## **MAINTENANCE AND STORAGE BUILDING SUBDIVISION**

APPLICATION NUMBER 18 DATE April 17, 2008

APPLICANT Maintenance and Storage Building Subdivision

REQUEST Subdivision

# DETAIL SITE PLAN

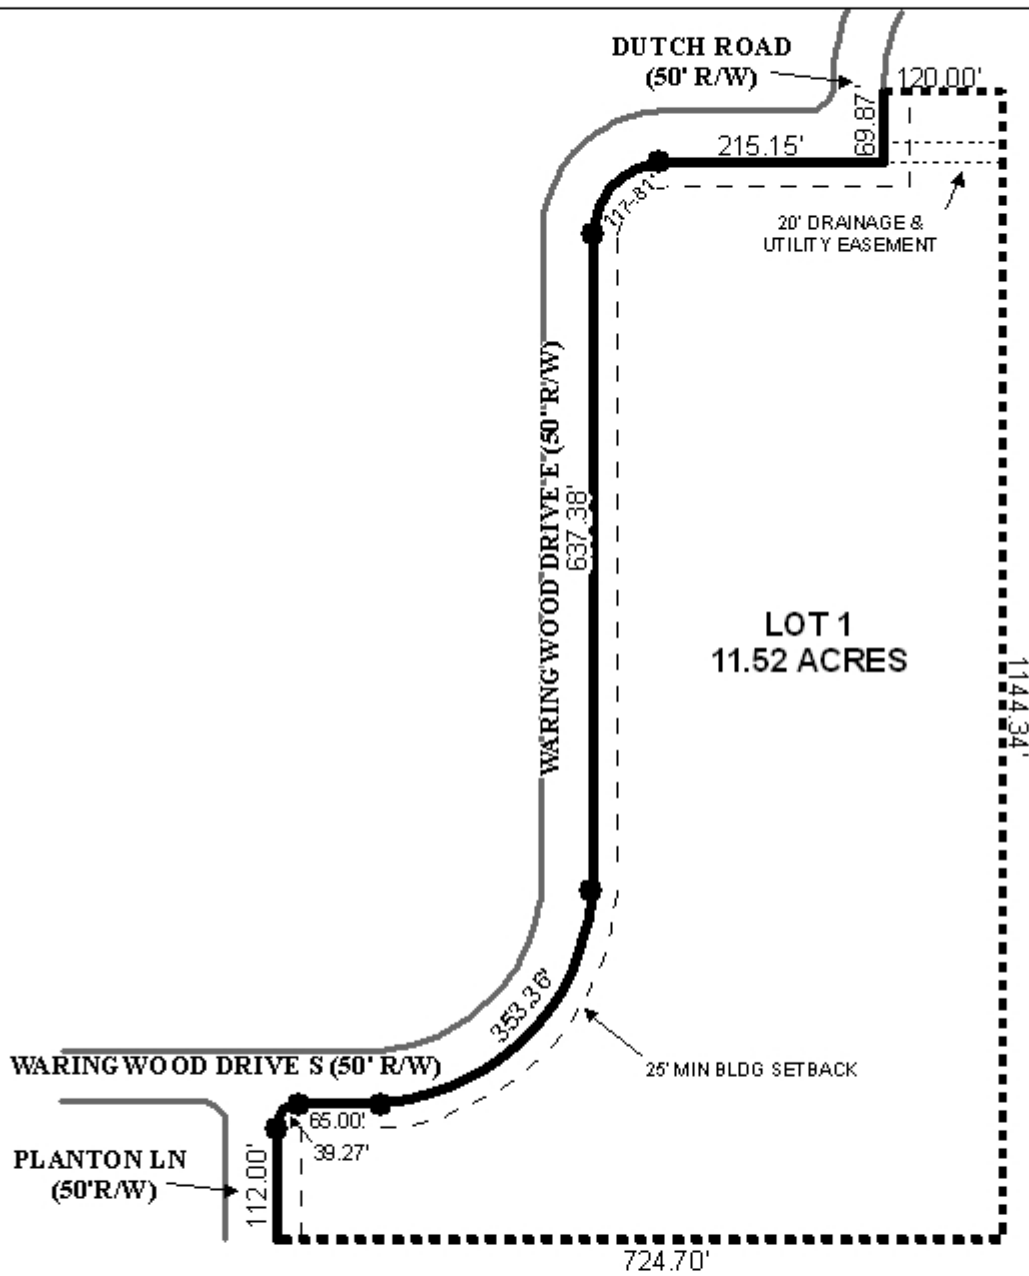
The site fronts Waringwood Drive East, Waringwood Drive South, and Planton Lane, all minor streets with existing rights-of-way widths of approximately 50 feet. The site is also split into three parts by Dutch Road, a minor road with an existing 50' right-of-way, and Moore Road, also a minor road with a 50' right-of-way. The applicant states that both Dutch Road, from Waringwood Drive East South and Moore Road are to be vacated. The preliminary plat indicates a 25' minimum building setback line along all remaining (unvacated) street rights-of-way. If approved, the 25' minimum building setback line should also be depicted on the final plat.

Currently there are four drainage easements on the property that are not shown on the proposed plat. If approved, there should be no signing of the final plat prior to the approved vacation of the four drainage easements. If vacation of easements does not occur, the easements should be depicted on the final plat.

The proposed lot will have approximately 1571'± of street frontage therefore access management is a concern. As a means of access management, a note should be placed on the final plat, if approved, stating that Lot 1 is limited to 4 curb cuts, with the size, location and design to be approved by Traffic Engineering and conform to AASHTO standards.

- 1) completion of the vacation process for Dutch Road and Moore Road;
- 2) completion of the vacation process for all current drainage easements not shown on the preliminary plat or depiction of easements on final plat;
- 3) depiction of a drainage easement for any structures that carry public water located in the vacated right-of-way;
- 4) demolition of any dwellings located on the property prior to signing of the final plat;
- 5) compliance with all storm water and flood control ordinances;
- 6) placement of a note on the plat stating that Lot 1 is limited to 4 curb cut, with the size, location and design to be approved by Traffic Engineering and conform to AASHTO standards; and
- 7) placement of a note on the plat stating that the site must be developed in compliance with all local, state and Federal regulations regarding endangered, threatened or otherwise protected species.
